Well Name: WF FEDERAL 28

Subsequent Report

Type of Action: Plug and Abandonment

WF FEDERAL 28 1R

Current Schematic - Version 3

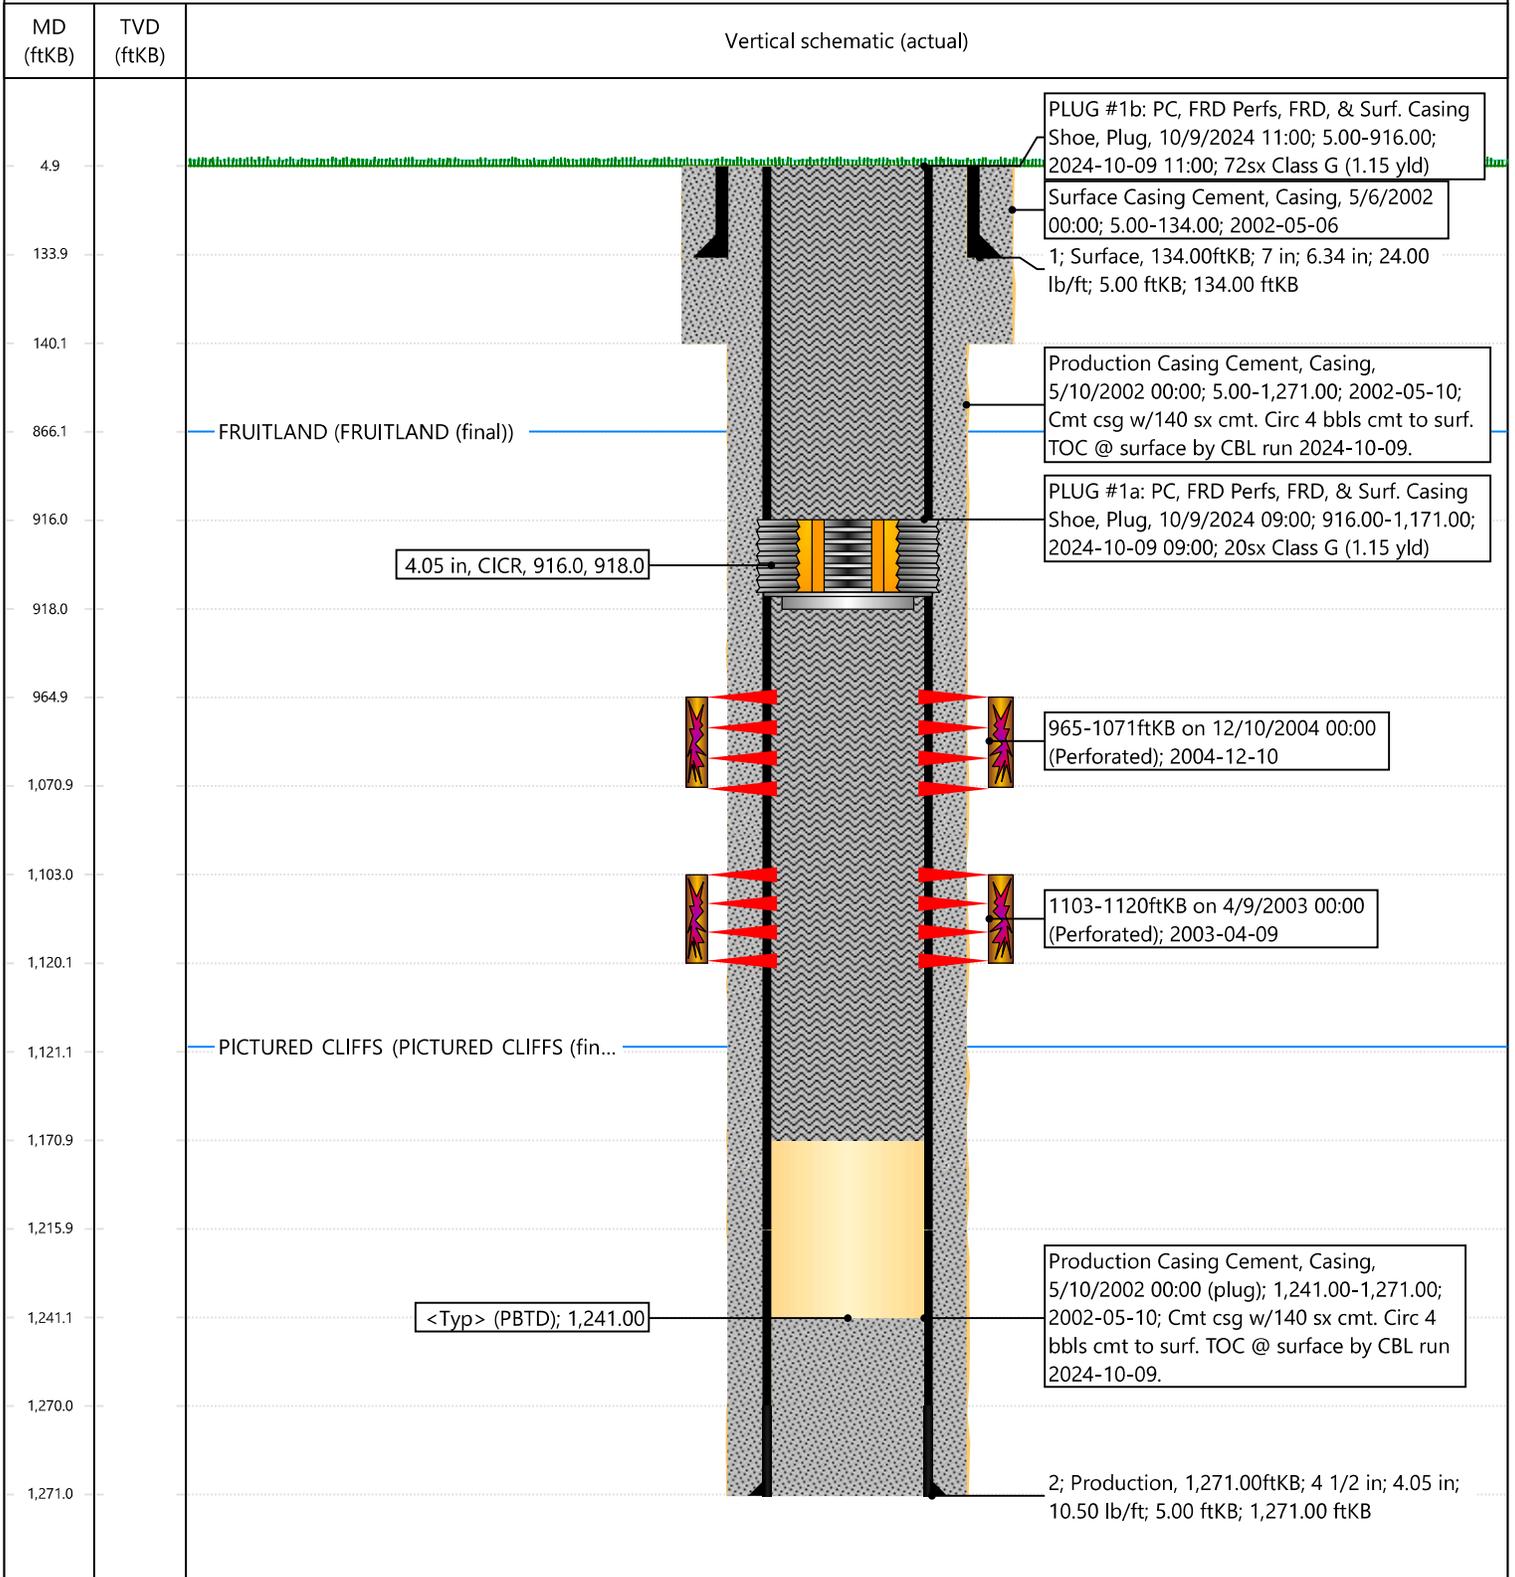
- Hilcorp will mill out the existing CIBP @ 925'
- Hilcorp received verbal approval from the NMOCD & BLM to set a **4-1/2" CICR @ 916'**, and establish an injection rate below the CICR.
- Hilcorp will then pump PLUG #1a beneath the CICR from **916' to 1,171' (Class G)**. Hilcorp received verbal approval from the NMOCD & BLM to forego pumping PLUG #1a if Hilcorp is unable to establish an injection rate beneath the CICR, and proceed with the remainder of the procedure.
- Hilcorp will then run a CBL; adjust plugs as needed.
- Hilcorp will then pump PLUG #1b above the CICR from **916' to surface (Class G)**.
- Please see the revised procedure attached and below. The updated Proposed P&A wellbore schematic is also attached.

6. **PLUG #1a: 20sx of Class G Cement (15.8 PPG, 1.15 yield); PC Top @ 1,121' | FRD Perfs @ 965' | FRD Top @ 866' |** Pump 20sx of cement beneath the 4-1/2" CICR (est. **TOC @ +/- 916'** & est. **BOC @ +/- 1,171'**). ***Note that this cement v volume to place cement 50' below the PC formation top. NMOCD also granted verbal approval to forego pumping establish injection rate beneath the 4-1/2" CICR @ 916', and proceed with the remainder of the procedure.**

9. TIH w/ work string & tag CICR @ **+/- 916'**.
10. **PLUG #1b: 72sx of Class G Cement (15.8 PPG, 1.15 yield); PC Top @ 1,121' | FRD Perfs @ 965' | FRD Top @ 866' |** Pump an 72 sack balanced cement plug inside the 4-1/2" casing (est. **TOC @ +/- 0'** & est. **BOC @ +/- 916'**). Wait on Cem ***Note cement plug lengths & volumes account for excess.**

To confirm, the BLM concurs with the evaluation.

NMOCD approves below

The BLM finds the updated procedure appropriate.
